Consultant Wahib Medanat Consultant Engineers Rep No. QC-11 03

Site Name Um Al Dananir Basic Mixed - Balqa Date 15 / 03 / 2021

Package Package 1

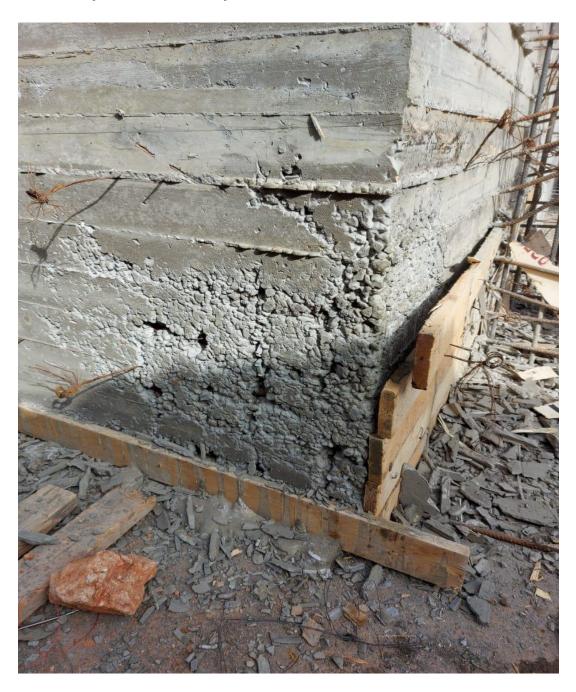
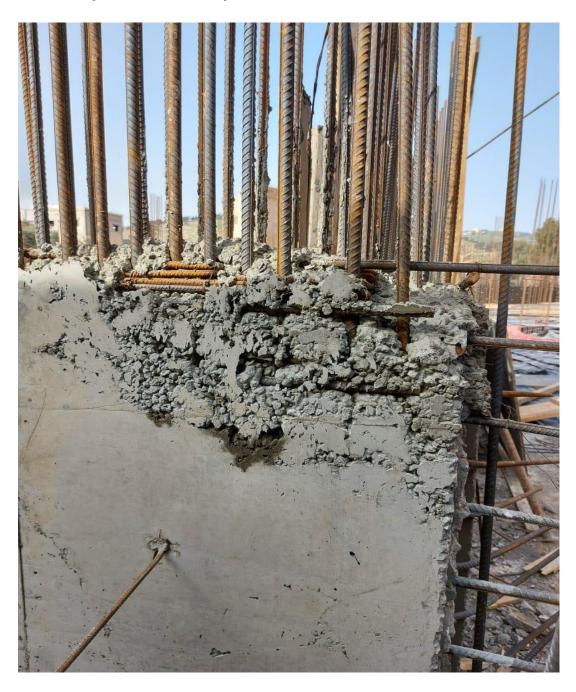
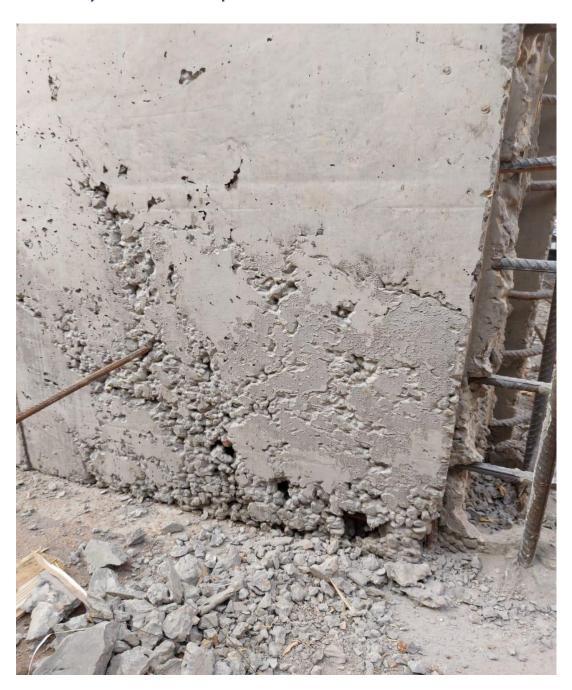
Description of Non Conformance	Corrective Action	Required by / When
Segregation and roughness in column neck no. (7) and (1)- axis J/7- K/7	Demolition of defected areas and re-cast in accordance to approved method statement	Immediately by Contractor
Report Prepared by	Hassan Shaqbua, Supervision Quality Control Manager

Community a Response		
	Site memo was issued to the Contractor and his action is awaited		
Notes
